DOCUMENT 00 90 10

ADDENDUM No. 3

- A. The Construction Contract is known as: *Mountain Green BNR Wastewater Treatment Plant*
- B. Date of this Addendum: 2/3/2023.
- C. All other provisions in the contract to remain in full force and effect.

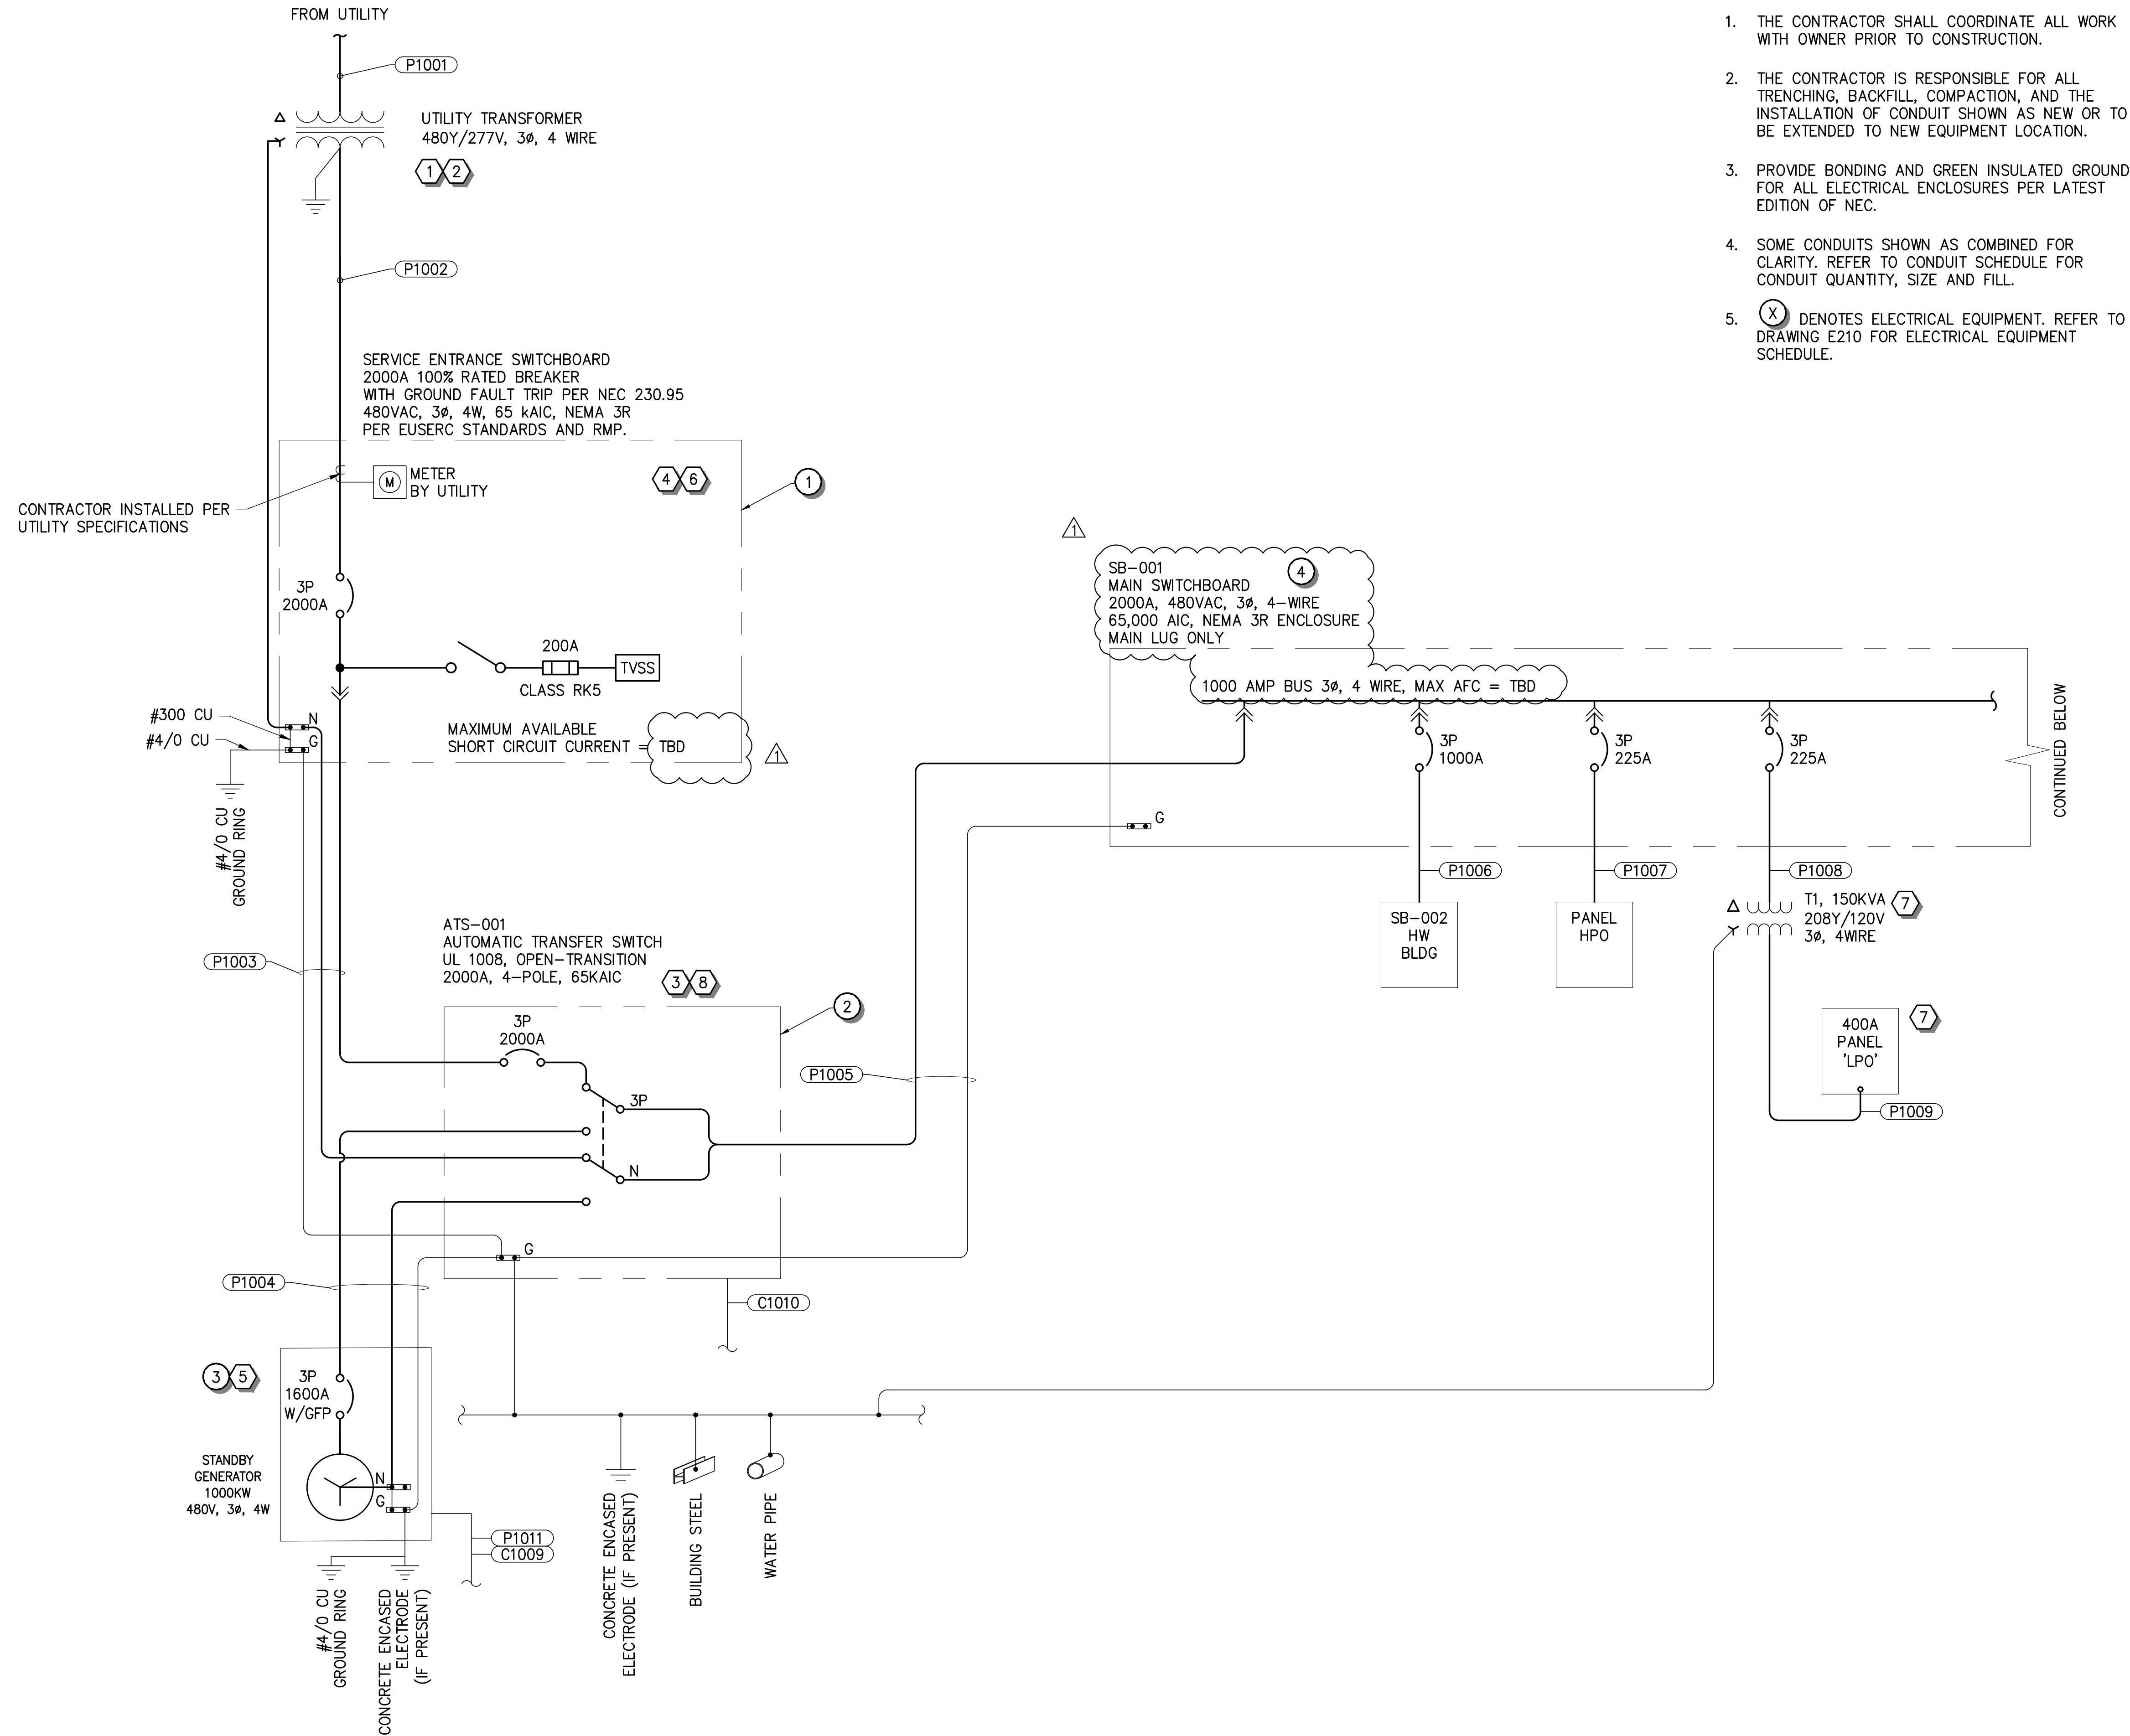
- 8) Question: Is the generator and transfer switches owner supplied?
Response: No, Please see attached sheet E-201 for revision. Generator and transfer switches contractor supplied.

23) Question: With the Generator being provided by the 'Owner' per specifications, does the E.C have the responsibility to provide a crane and concrete generator pad for setting this? If so, are there any minimum specifications that are required for the generator pad? Also, is it the E.C.'s responsibility to fill the generator with fuel and top it off after testing, assuming it's diesel. Is this Diesel or Natural Gas?

Response: Generator is to be supplied by Contractor per Specification 16817SP. Key Note #5 on Drawing E201 had been corrected. Generator pad details to follow.

ENLARGED CLARIFIER ELECTRICAL PLAN

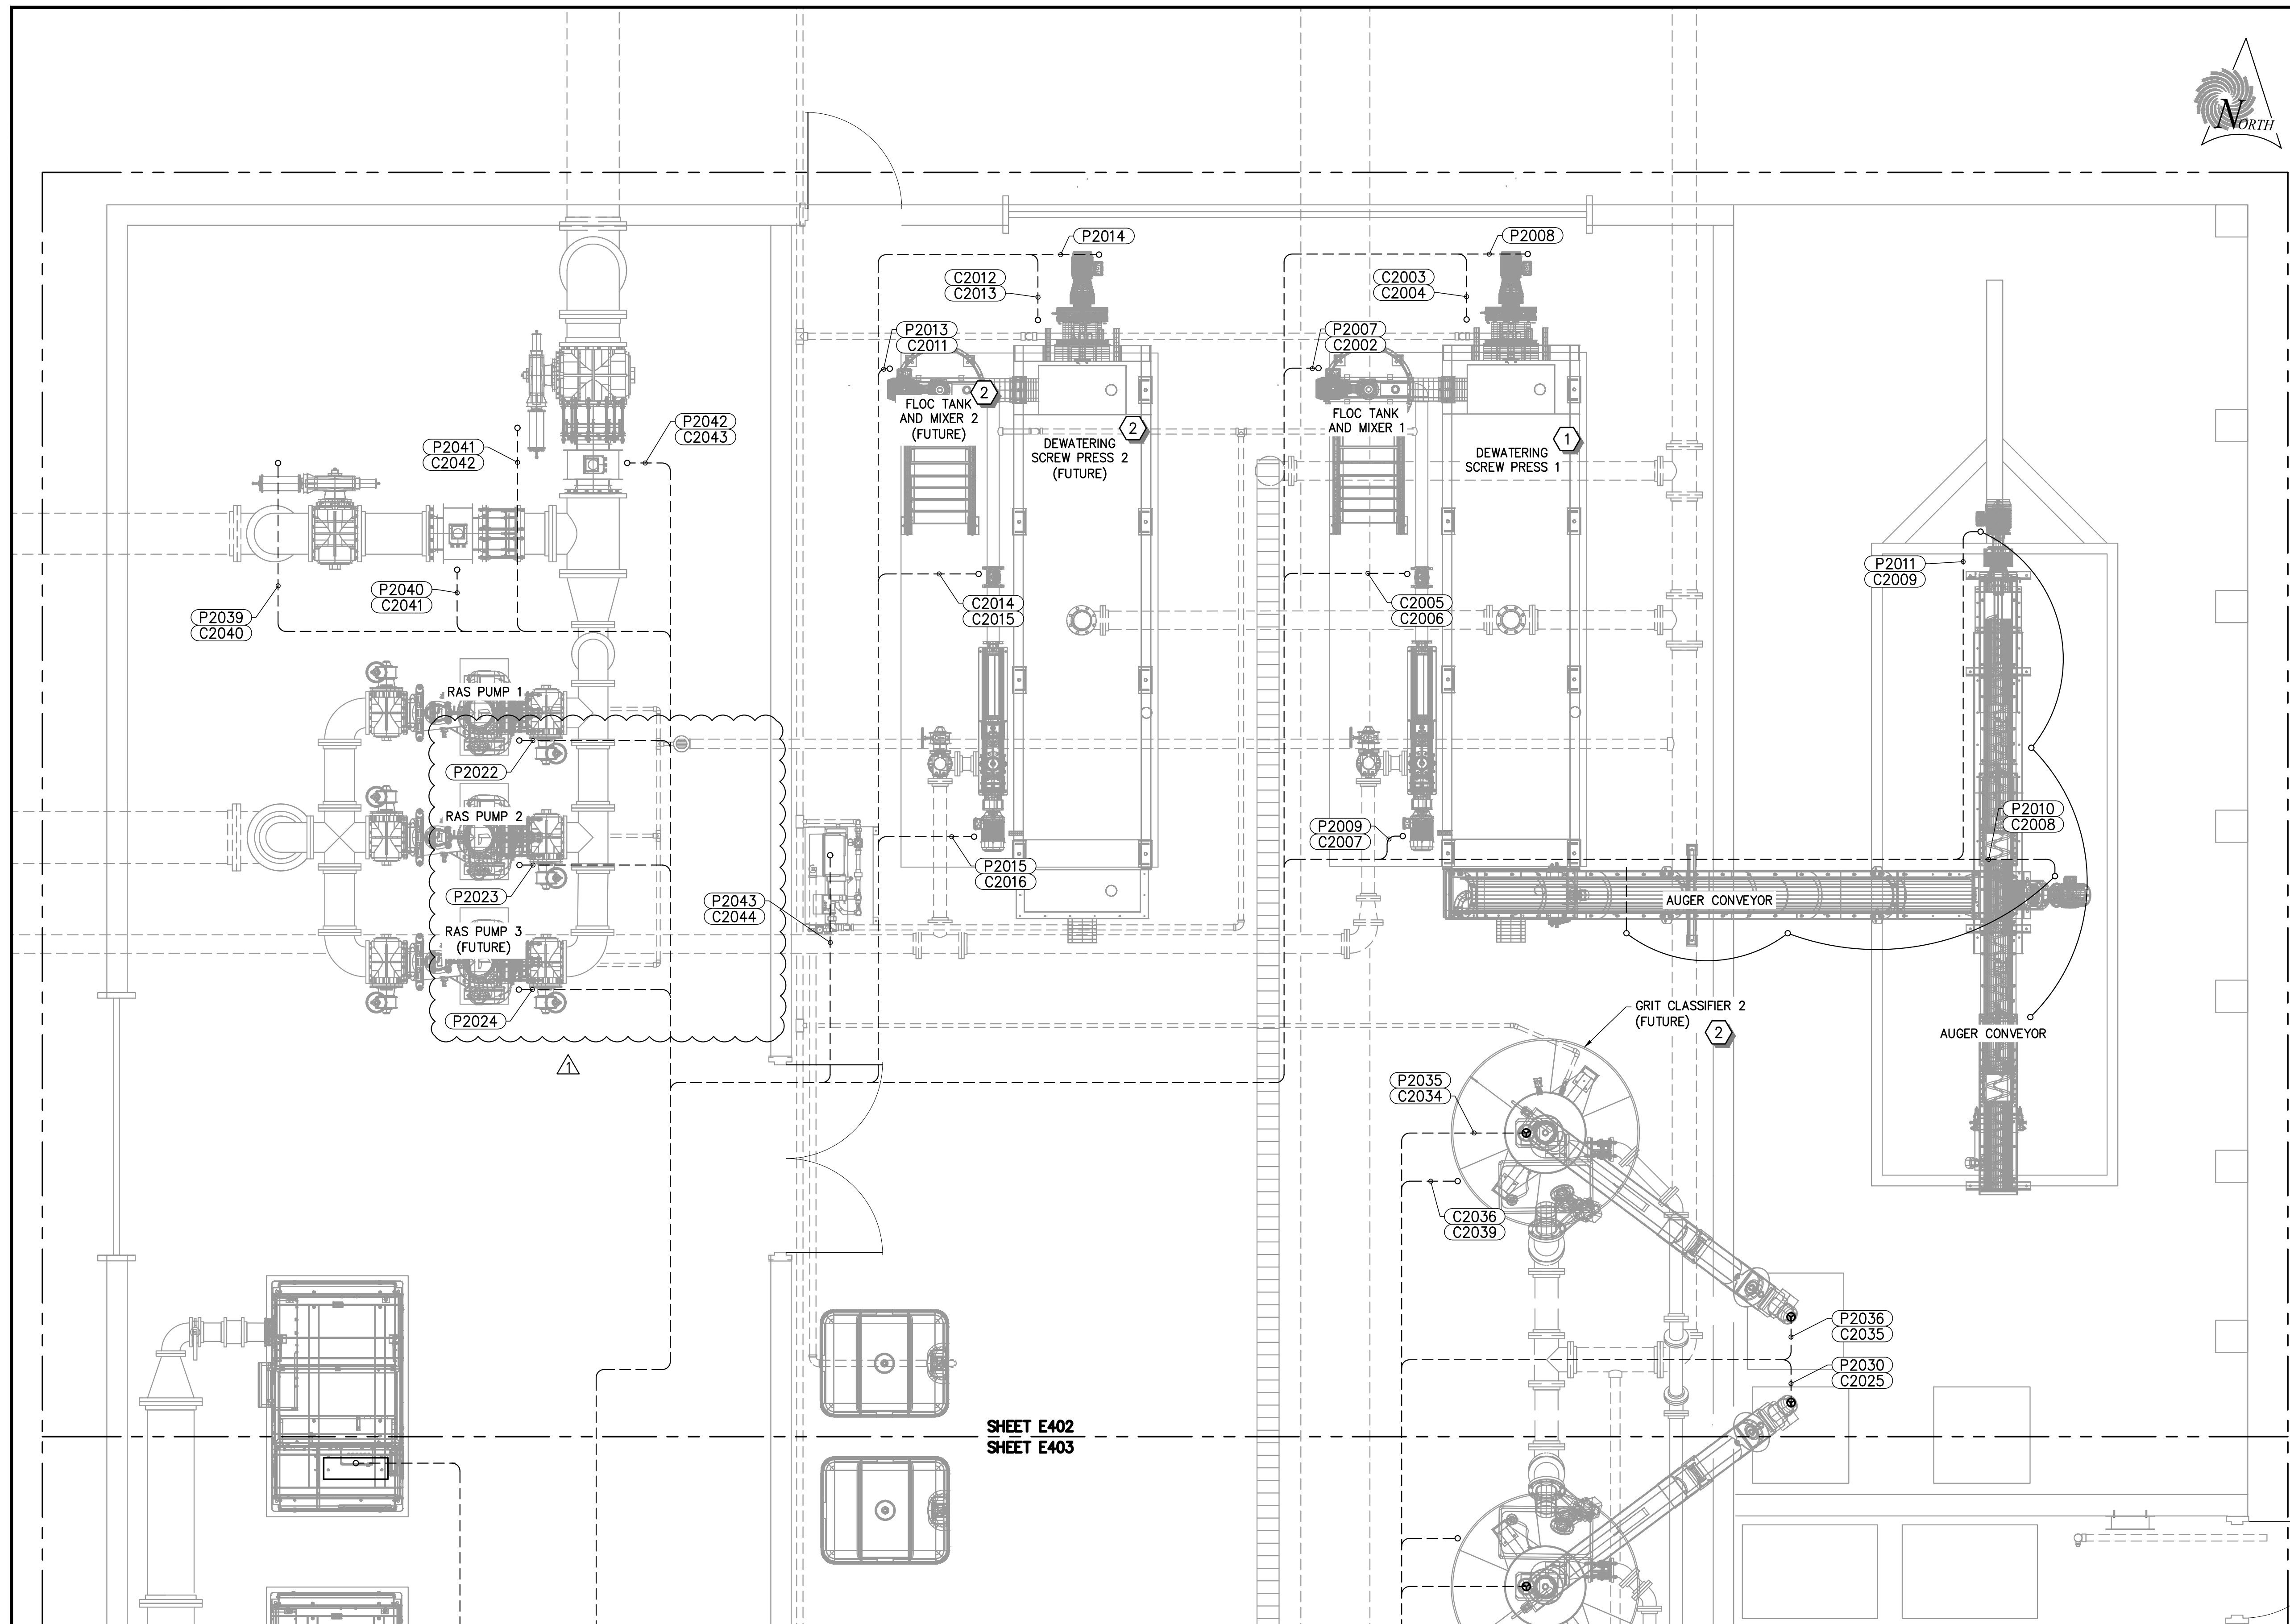
17) Question: Concerning drawing E307. Is the scale of 1" = 60' correct? Or is it closer to 3/16" = 1'? Also are Clarifier # 1 and Clarifier # 2 identical take off related to that drawing, so this drawing x 2?

Response: It looks like that should have been 1" = 60" or 5', NOT 60'. The drawing is shown as a typical, so the same information for Clarifier #1 and Clarifier #2.
